CBJ DOCKS & HARBORS BOARD
OPERATIONS/PLANNING COMMITTEE MEETING AGENDA
For Wednesday, August 12th, 2015

DOUGLAS HARBOR RENOVATION
CBJ PROJECT - DH16-001

Subject: Douglas Harbor Renovation, DH 16-001
35% Design Review Submittal

PUBLIC COMMENTS

SHEET TITLE:
SITE PLAN CONCEPT NO.2

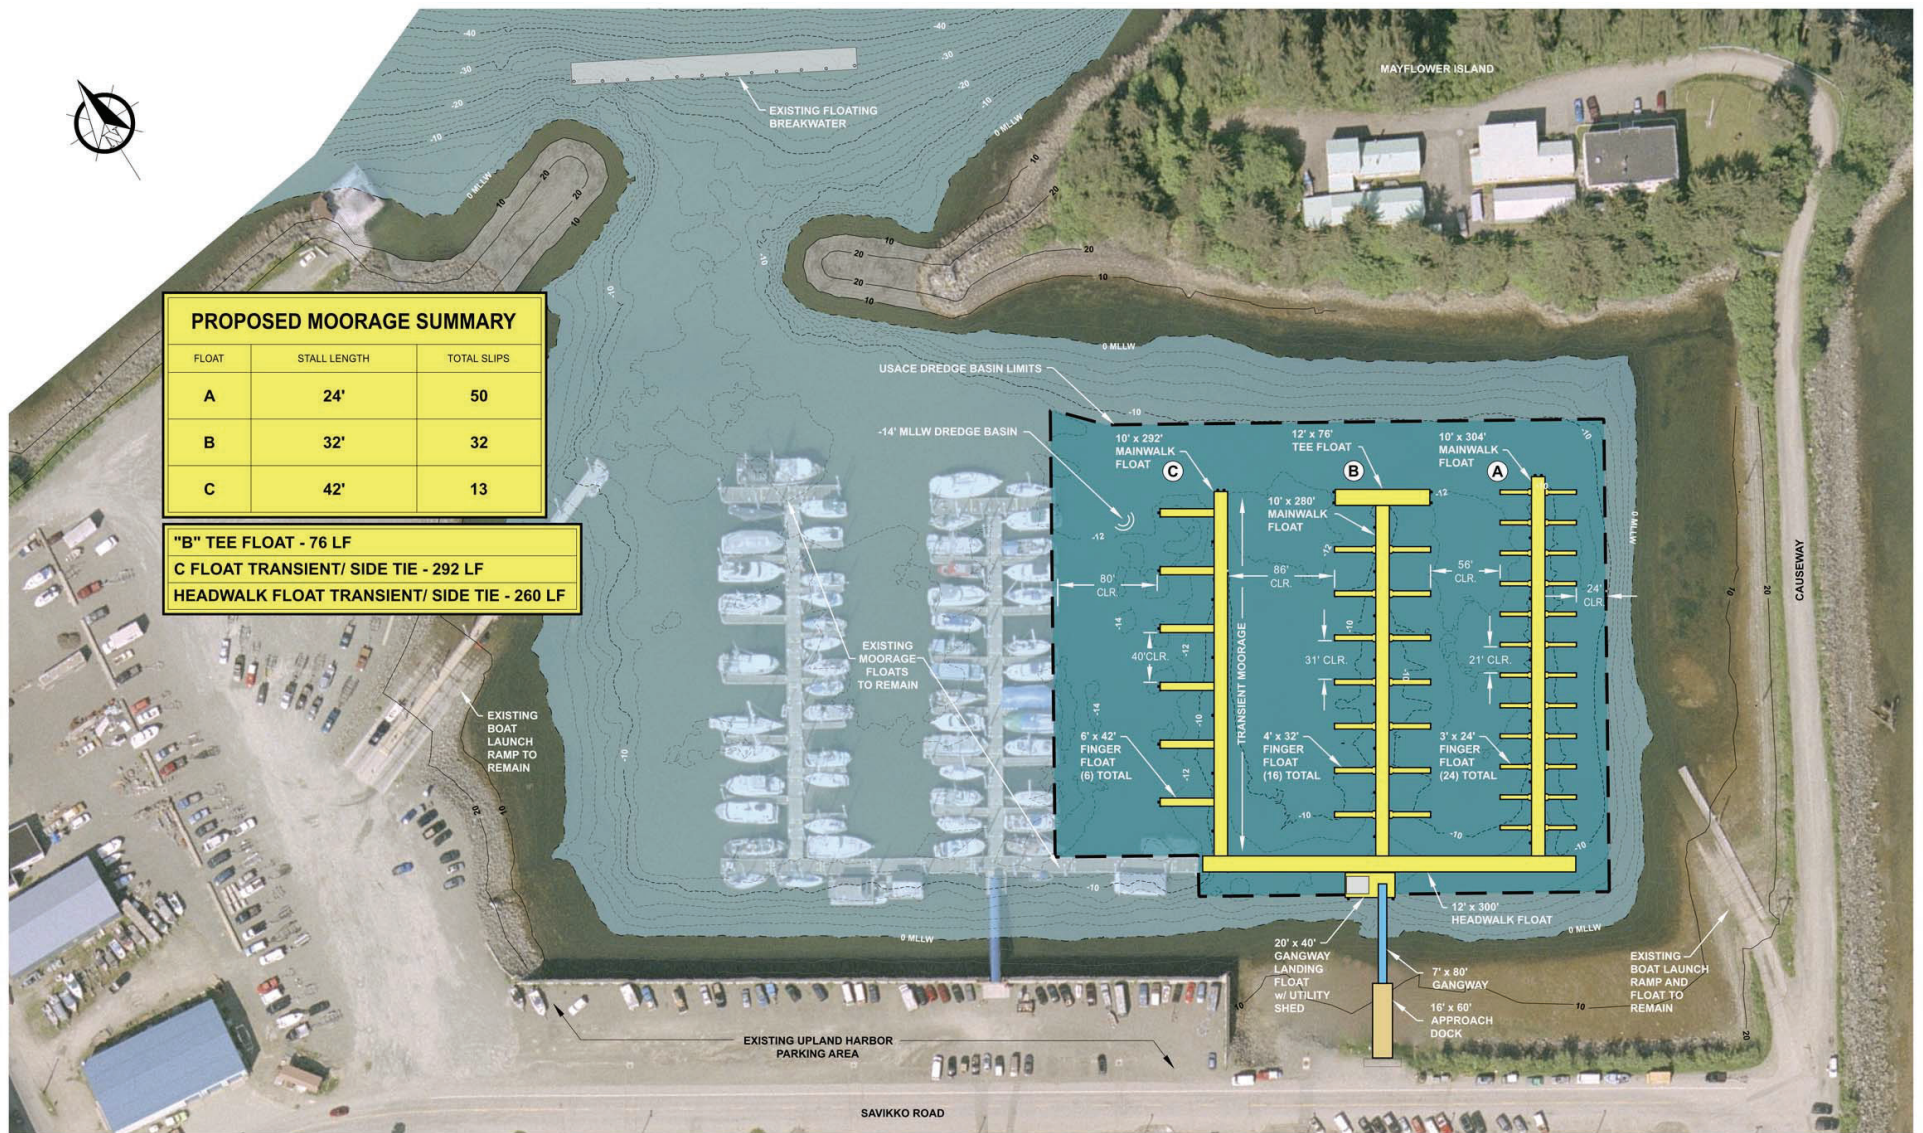
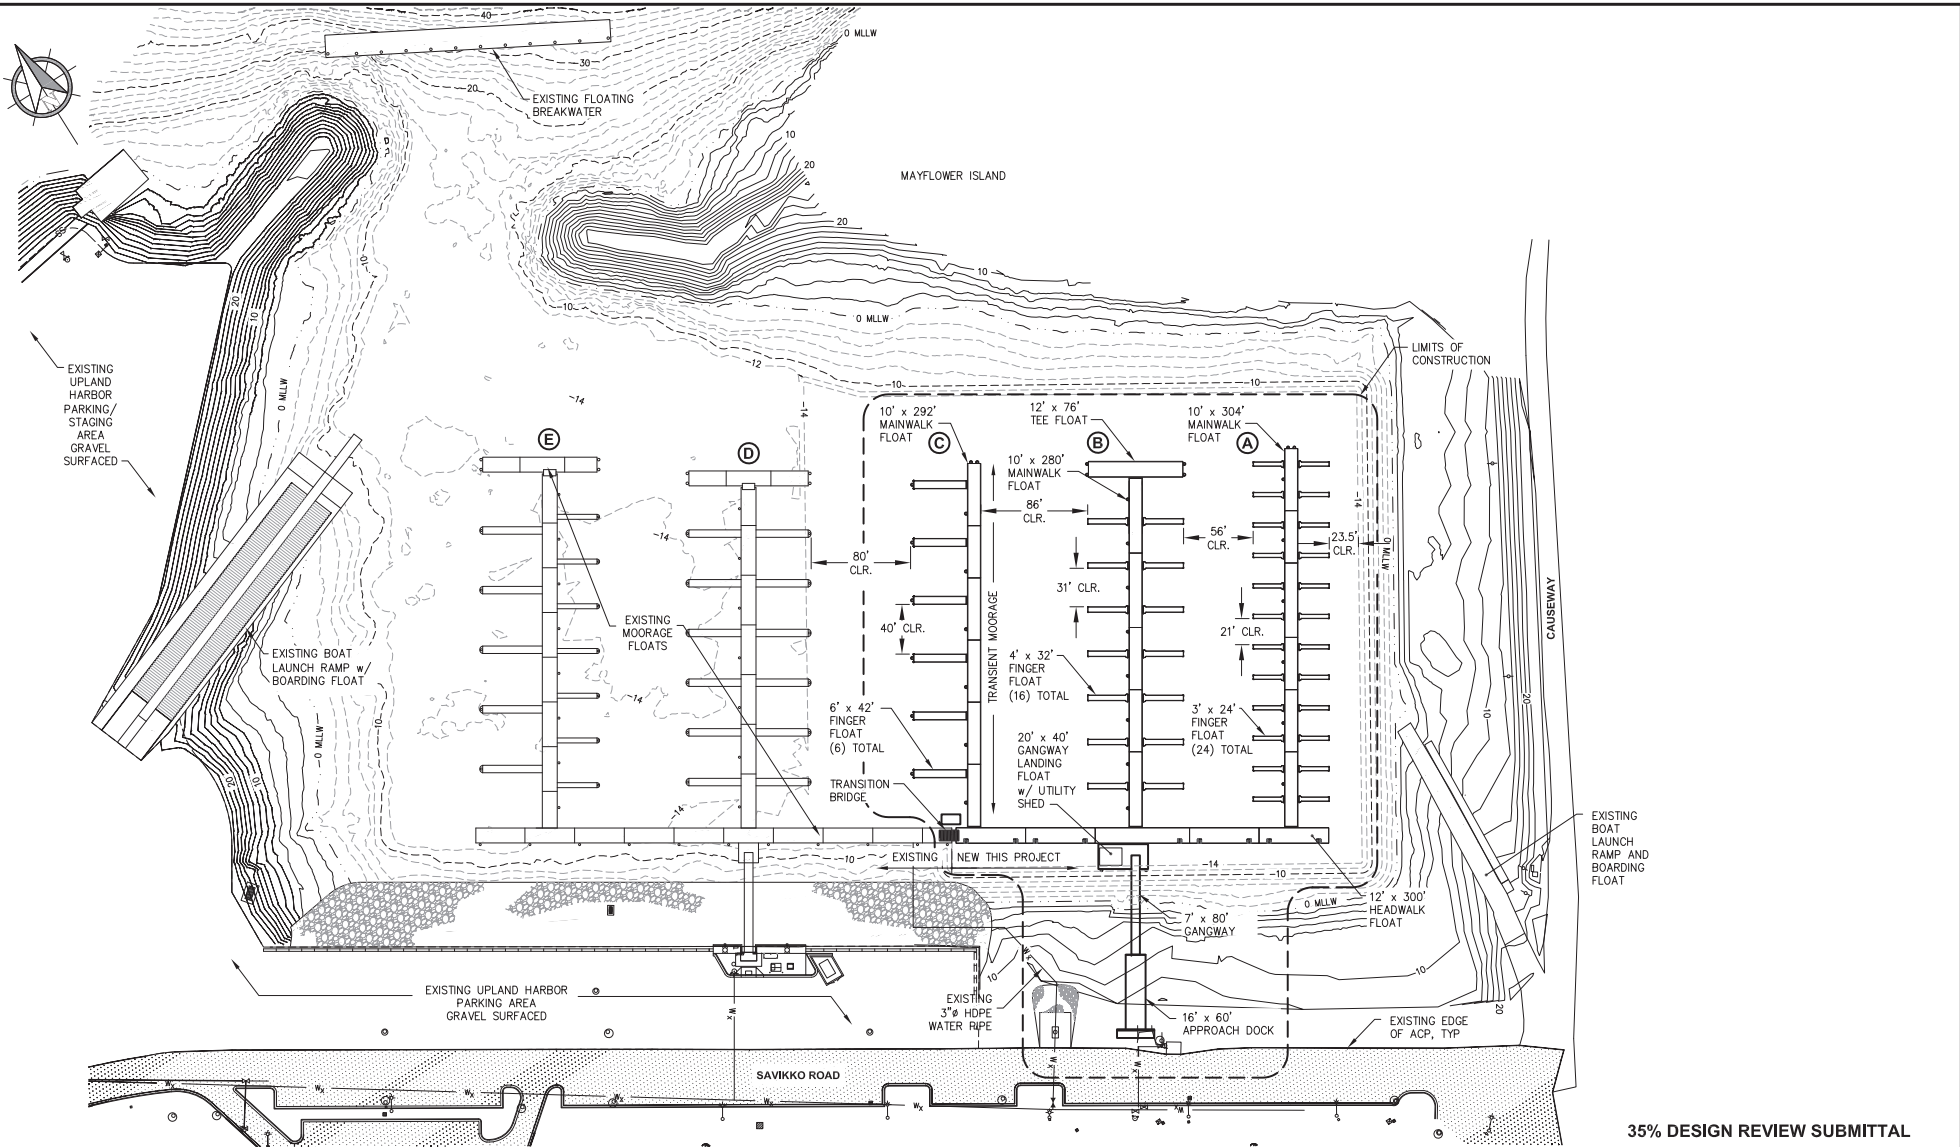
Q: Why have the skiff fingers been eliminated?

Q: How deep will the harbor be on the inside of the headwalk?

Q: Could a pair of fingers be removed from A float to make all stalls wider?

Q: Can the tee on the end of B float be made 12ft wide instead of 10ft? Relocated towards Mayflower island slightly to increase stall widths?

PLEASE EXTEND "A" FLOAT TO INCREASE
CLEARANCE BETWEEN FINGERS.

Place Pilings inside on Head Float for longer vessels.

Place 30/50 amp receptacles along new Head Float.

"A" Float 10 to 12' longer for wider slips

1. **Float Layout Changes:** Berth width on the 24' finger floats on Mainwalk A were increased from 20' to 21', which increased Mainwalk A length to 304'. Berth width on the 32' finger floats on Mainwalk B were increased from 30' to 31' and the Tee Float was increased in size to 12'x76'. The Headwalk float was lengthened by 24' in order to provide another 24' stall on A Float.

A: Lack of demand, small boats tend to be trailered today, and eliminating the skiff fingers allowed the remaining stalls to be made larger.

A: The water depth will be -14ft MLLW.

A: Yes, this would eliminate 4 moorage stalls, a better option would be to lengthen A float.

A: Yes
